OLT-specifiable Sync Pattern and Burst Delimiter

Jeff Mandin - PMC-Sierra
Duane Remein – Alcatel-Lucent

802.3av Seoul meeting
Sept 2008

New Fields in Discovery GATE (77-31)

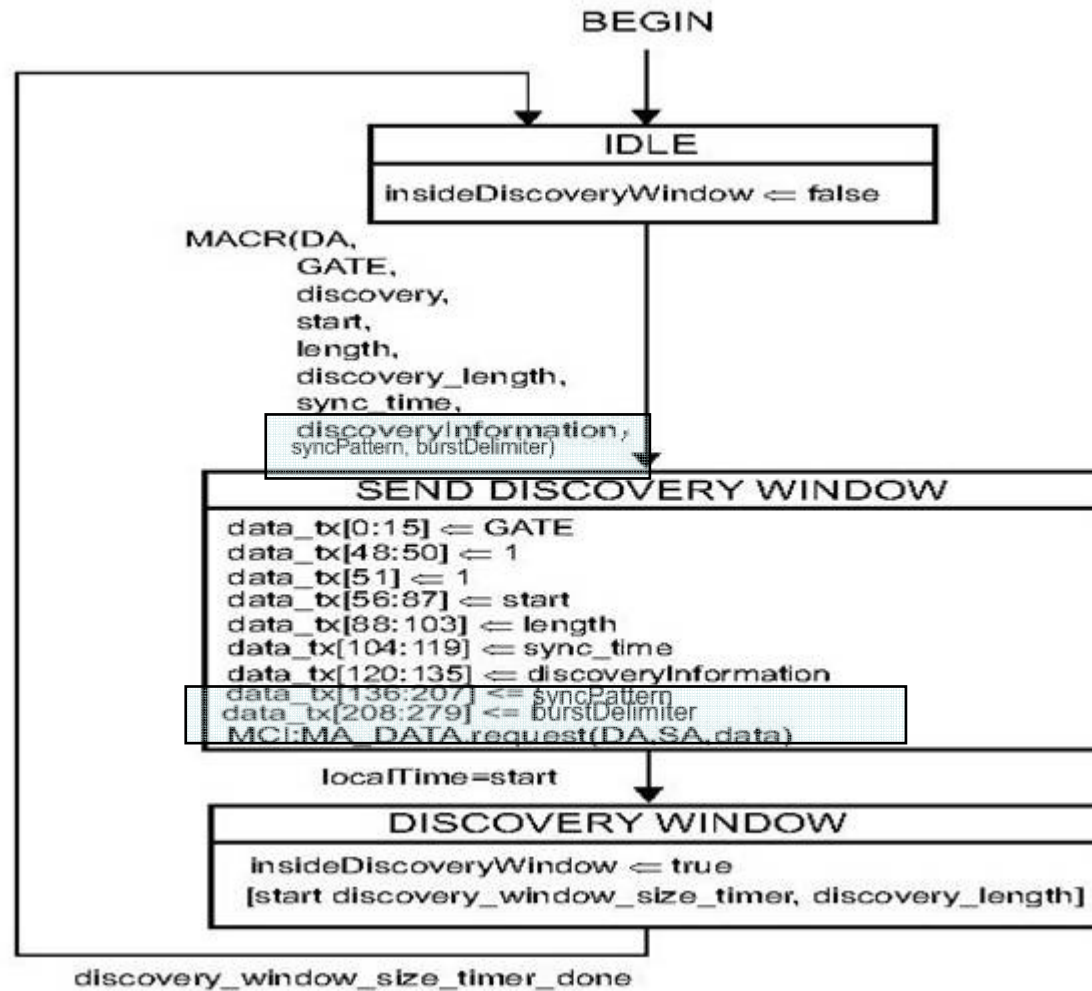
The OLT specifies the Sync Pattern and Burst Delimiter to be used by all ONUs transmitting in the discovery window at 10 Gb/s
